<p><u>Meeting</u></p> <p>Strategic Planning Committee</p>
<p><u>Date and time</u></p> <p>Wednesday 7th September, 2022</p> <p>At 7.00 pm</p>
<p><u>Venue</u></p> <p>Hendon Town Hall, The Burroughs, London NW4 4BQ</p>

**ADDENDUM TO SERVICE DIRECTOR OF DEVELOPMENT MANAGEMENT AND
BUILDING CONTROL'S REPORT**

20/3742/FUL – Broadfields Estate, Bushfield Crescent, Edgware, HA8 8XH

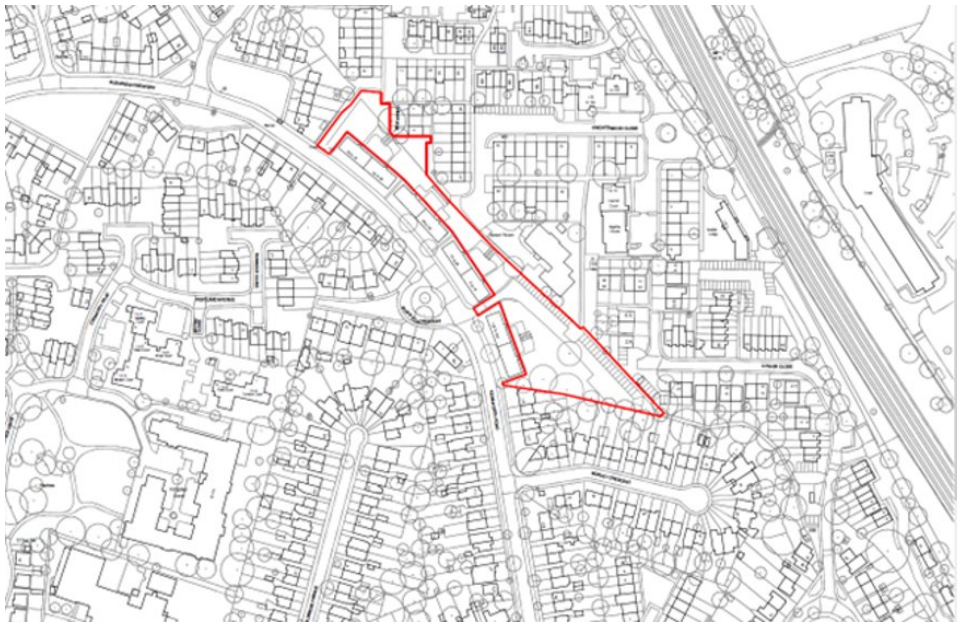
Incorrect site plan uploaded with report, site plan for the application is as below;
